**Consultation note regarding third draft of the LRAIC fixed model**

DBA started the consultation on the third version of the draft LRAIC fixed model the 5<sup>th</sup> of June 2014. By the end of the consultation period, the 2<sup>th</sup> of July 2014, DBA had received consultation responses from Telenor, Telia, Concepy and TDC.

### *Holes for joints*

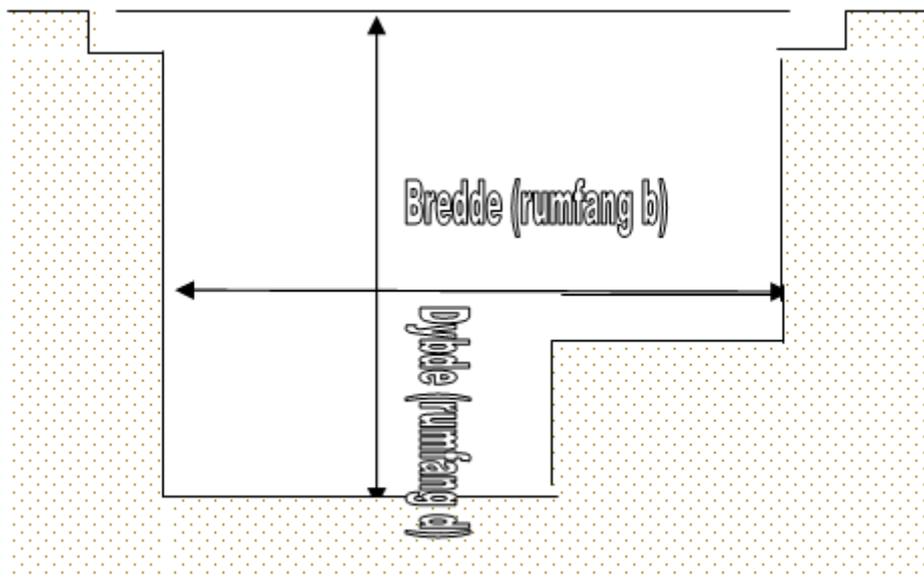
TDC finds it questionable that DBA put a great weight to the statement of Global Connect, a fiber network only provider, when it comes to production of joints in the copper net. Benchmark exercises done on copper network deployment should be done with copper network experts.

Jointing copper and fiber is technically and methodically two very different working processes.

While it makes sense to consider the optimal use of jointing holes for the network, it is unrealistic to remove them completely.

The above drawing show the joint hole structure that allows the technician to sit in the hole working with the cables on his knees.

While method 'b' is doable in theory it seldom applies in the real world, partly because of safety regulations and partly because of coordination and timing. Digging regulations dictate that only 50-100 meter trench is open at a time. This means for the digging crew not to have any waste time, they have to continuously cover up the trench while digging further along. That does not allow waiting for jointing to be done. Hence method 'b' is out of the question, since jointing of copper cables is very time consuming (for example 6 hours for jointing two 200p cables). That means that if DBA wishes to exclude jointing holes from the model, the submitted cost of digging does not apply since the contractors digging crew would be very ineffective and very expensive. Even if method b) was used, extra cost should be incurred, since the joint closure has greater dimensions than the cable, and trench should be enlarged accordingly
